### Hurricane Planning Commission Meeting Agenda

September 26, 2023

1. FSP23-30: Discussion and consideration of a possible approval of a final site plan for the Hurricane City Gymnasium located at 748 N 200 W. Hurricane City, Applicant. Karl Rasmussen, Agent.
2. FSP23-31: Discussion and consideration of a possible approval of a final site plan for Hurricane High LDS Seminary located at 310 W 100 S. Mike Davey, Applicant.

## STAFF COMMENTS

SITE PLAN FOR:  
**HURRICANE CITY GYMNASIUM**  
LOCATED AT 748 NORTH 200 WEST  
HURRICANE, UTAH

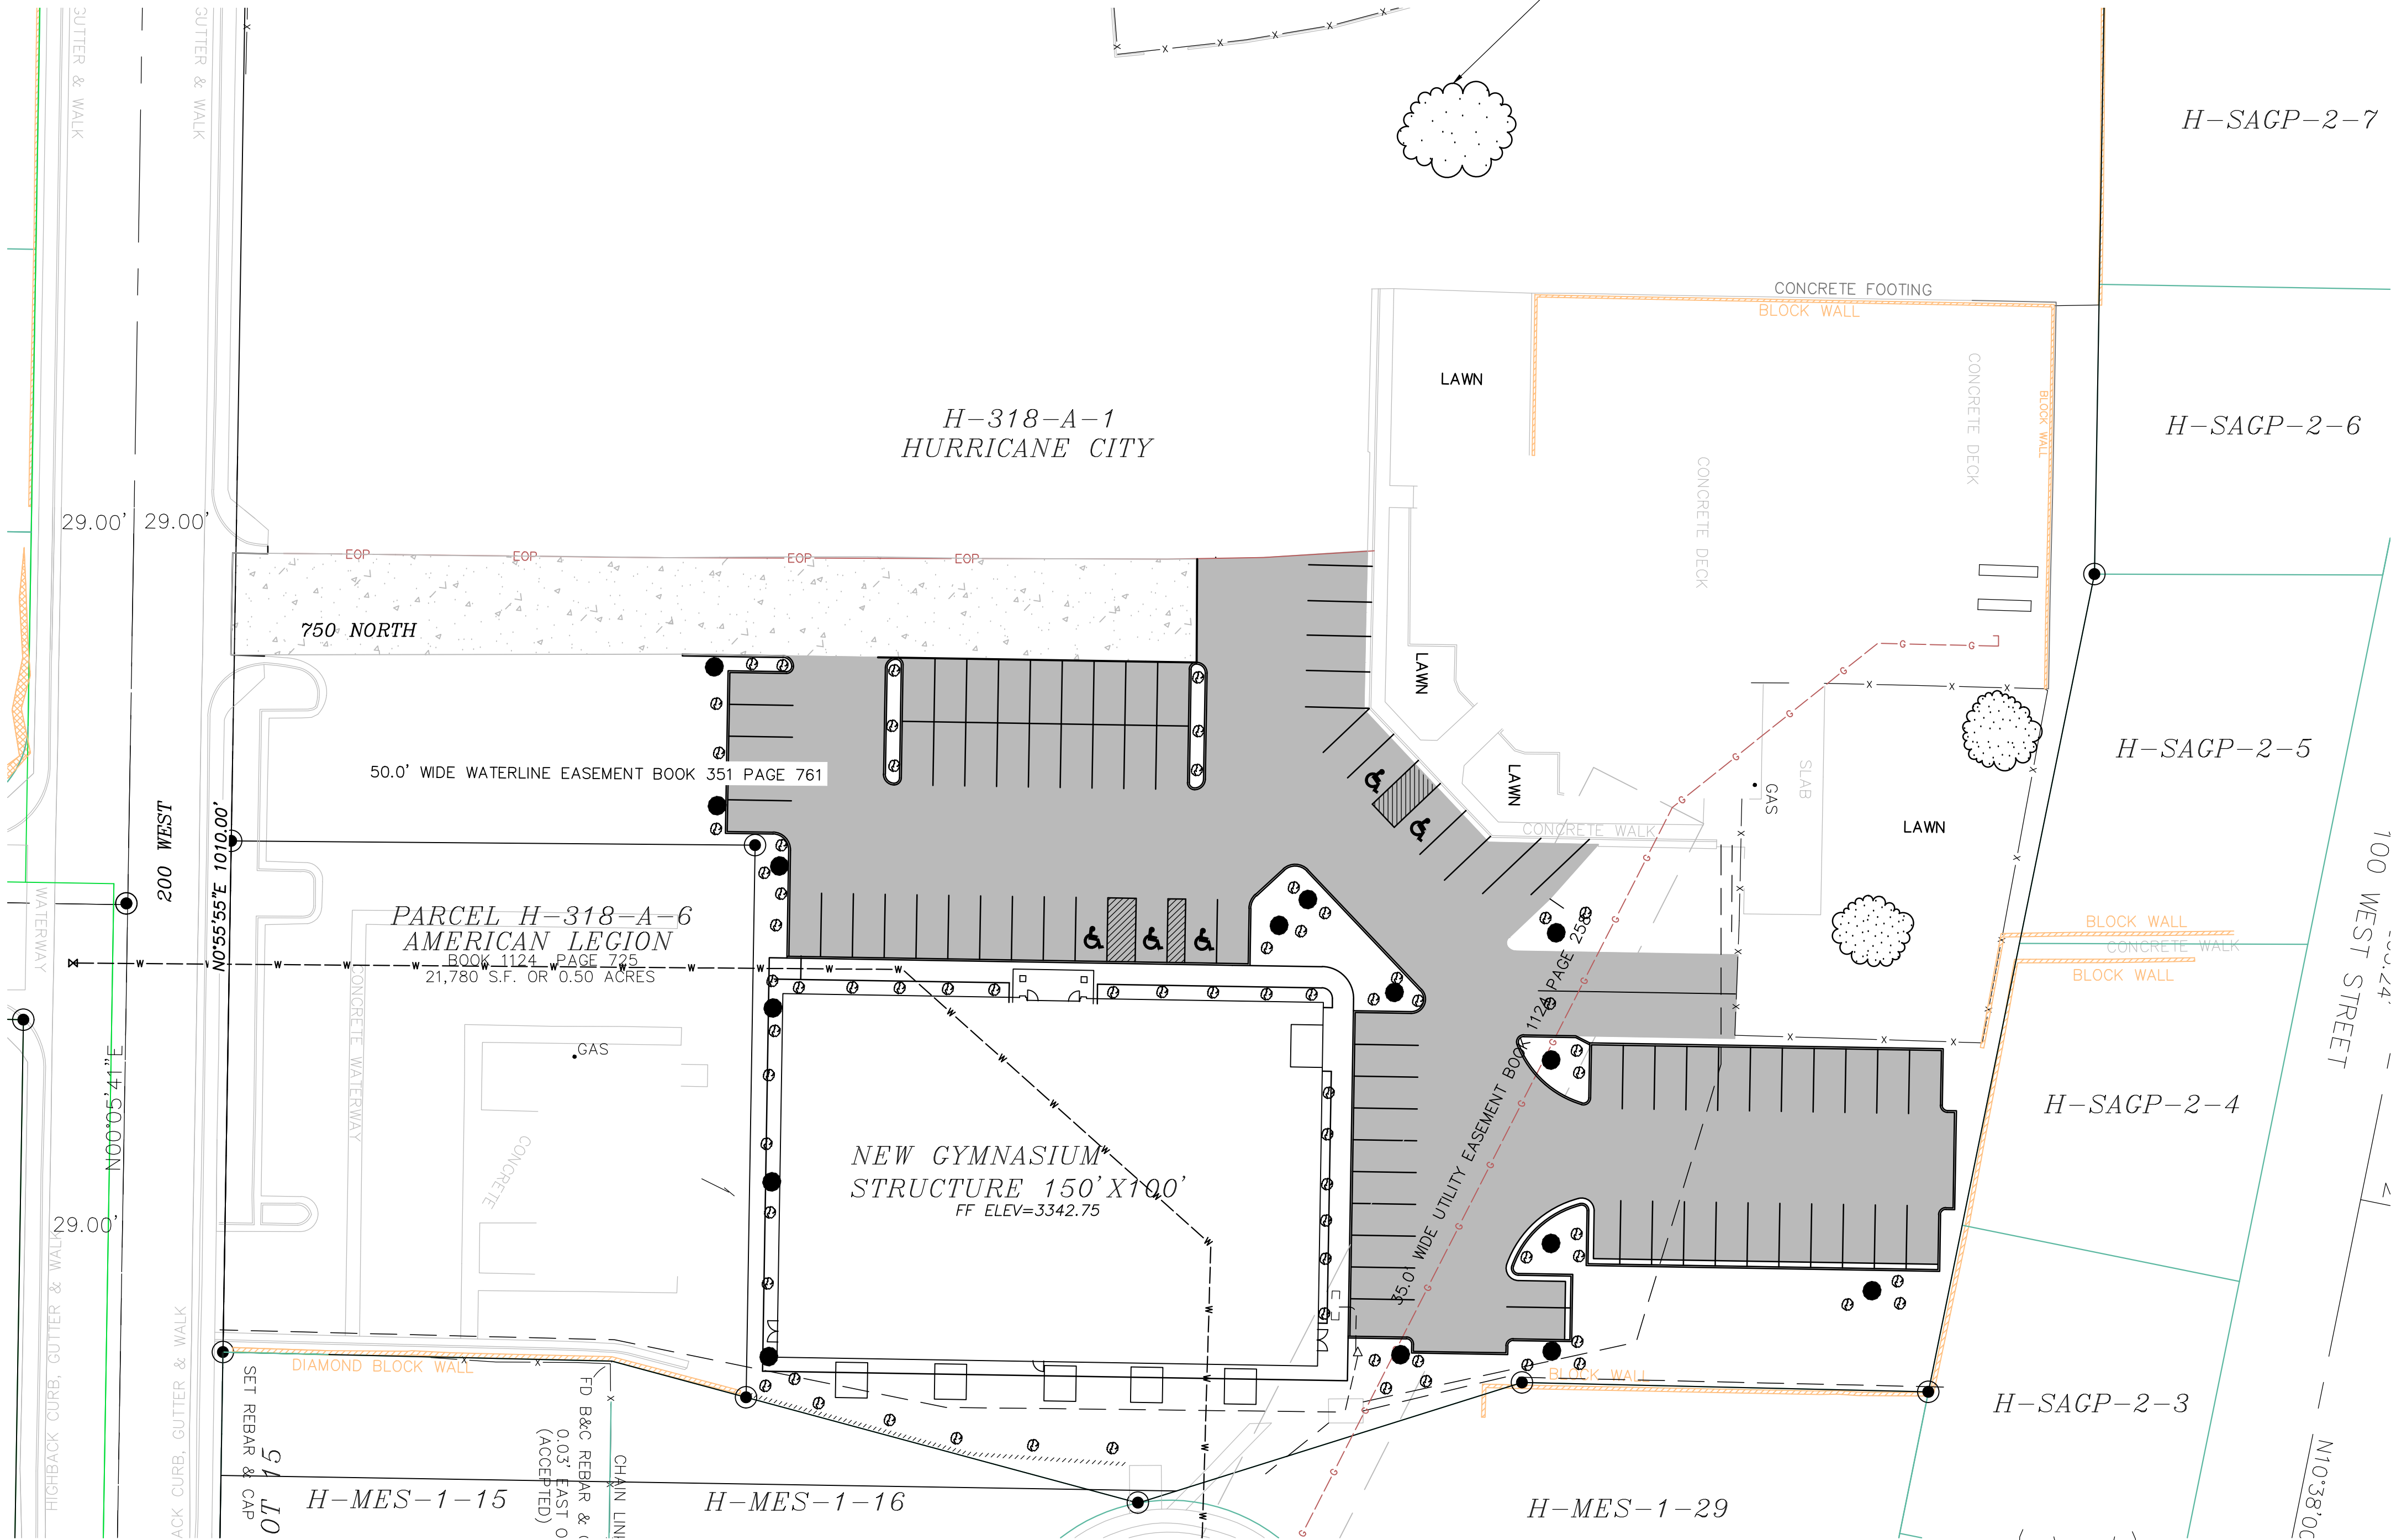
The applicant is proposing a 15,000 sq ft building. Under the parking standard they are required to provide 50 parking stalls. They are proposing 82 parking stalls in a different configuration than what is existing, which will also be used by the existing city pool and baseball diamonds. There are approximately 45 parking spaces already on site (some of the paint lines are faded). The City is in the process of master planning this site north of the pool building which will most likely provide more parking areas.

3. Landscape: Hurricane City code 10-32-6 requires that for landscaping this site seven percent of the parking lot shall be landscaped and one tree and two shrubs should be provided for every ten parking spaces.
  - a. The landscaping plan shows about 21% of the parking lot is landscaped and 25 trees and 70 shrubs which is sufficient to meet this code.
4. Pedestrian circulation throughout the site should be considered in the design. There is expected to be a large amount of pedestrian cross traffic between the different uses on this property, as well as to the neighboring streets and neighborhoods.
5. An outdoor lighting plan has been submitted that meets HCC 10-33-7. All lighting will need to be under 4000 K and focused downward.
6. Building elevations have been submitted. The gym building is 38' tall, however there is no maximum height in the Public Facility zone.

**Recommendation:** Staff recommends the Planning Commission review this application based on standards with Hurricane City Code. Staff would recommend approval subject to staff and JUC comments.

## Site Architectural Plan

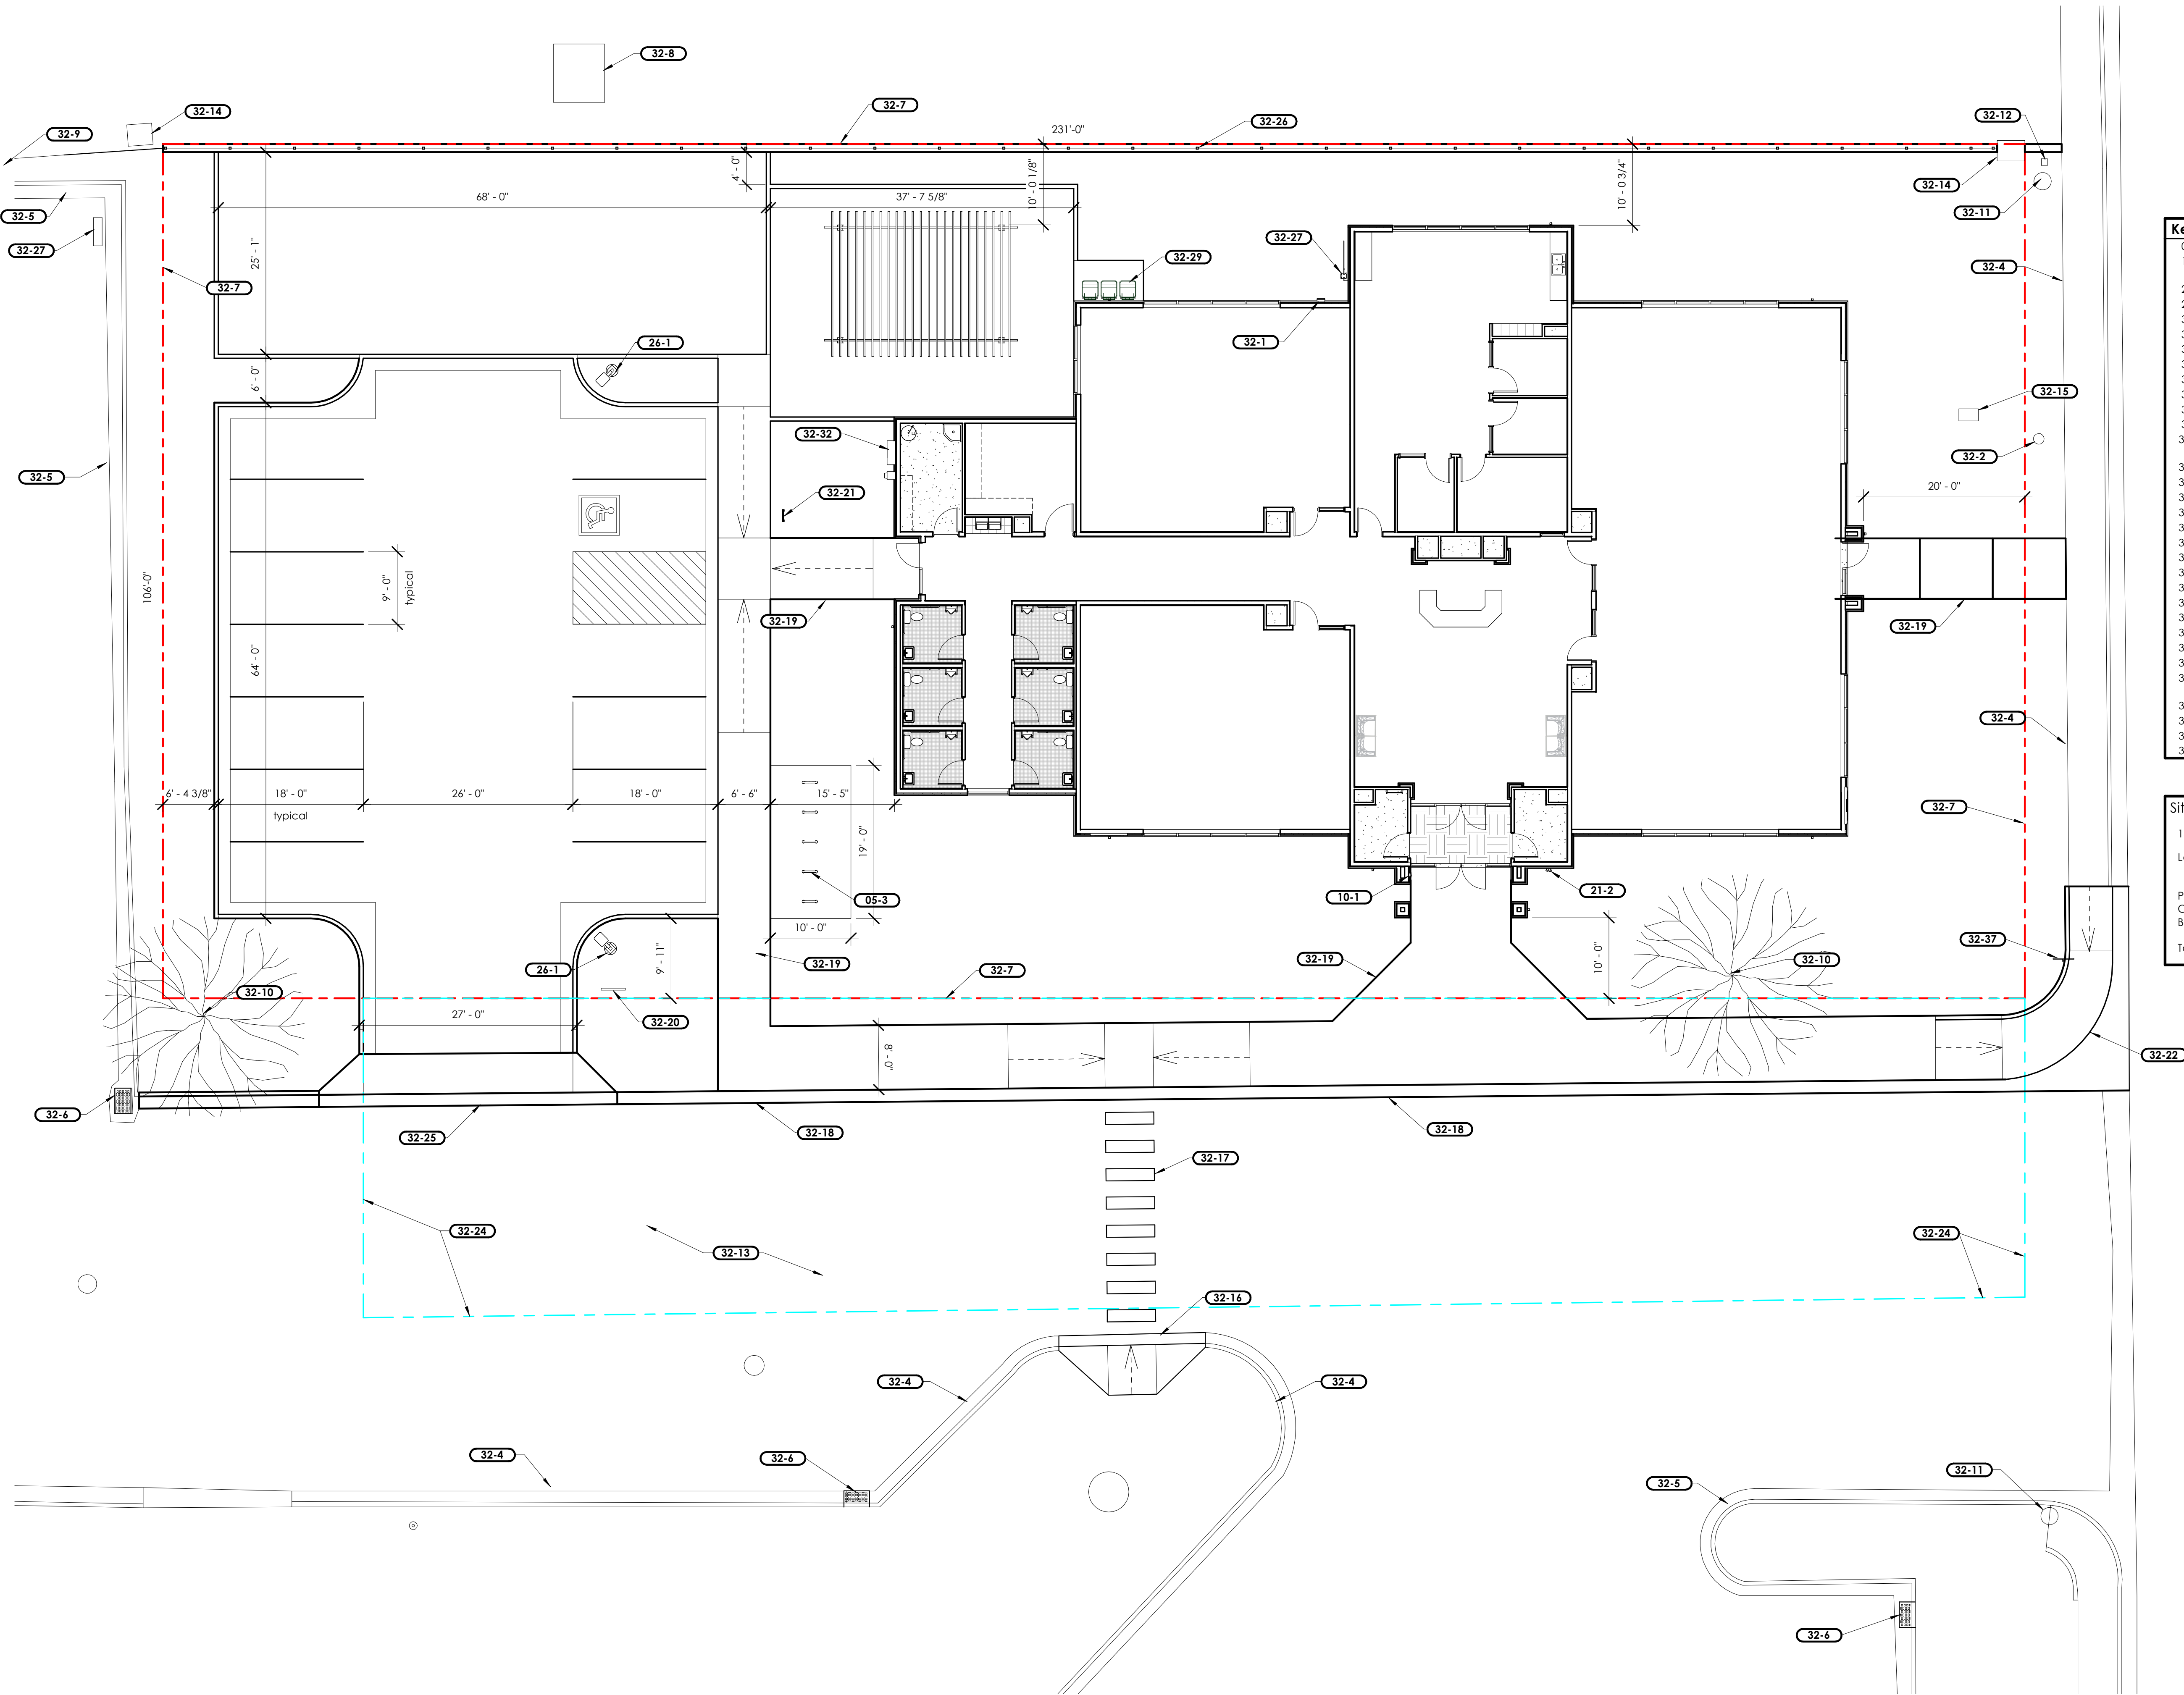
3. The applicant is proposing 13 parking stalls, which is the same as what currently exists on site but in a different configuration. The applicant has submitted a letter from their engineer stating that the current parking levels suit their need and they do not project more parking will be needed. The Planning Commission can approve a variation in parking standards under HCC 10-34-9

- a. The landscape buffer currently in place is shown to remain. The plan does show a 1700 sq ft grass lawn area, HCC 10-32-12(B)(1) states, "Grass is not permitted outside of an active recreation area. In addition, grass is prohibited in all landscape areas less than eight feet wide and on any slope that exceeds 15 percent." Due to its size and location within the site staff would consider this to be an "active recreation area"

*a.* Staff recommends approval of the parking modification.

**Recommendation:** Staff recommends the Planning Commission review this application based on standards with Hurricane City Code. Staff recommends approval of this final site plan and parking requirement modification subject to JUC and staff comments.
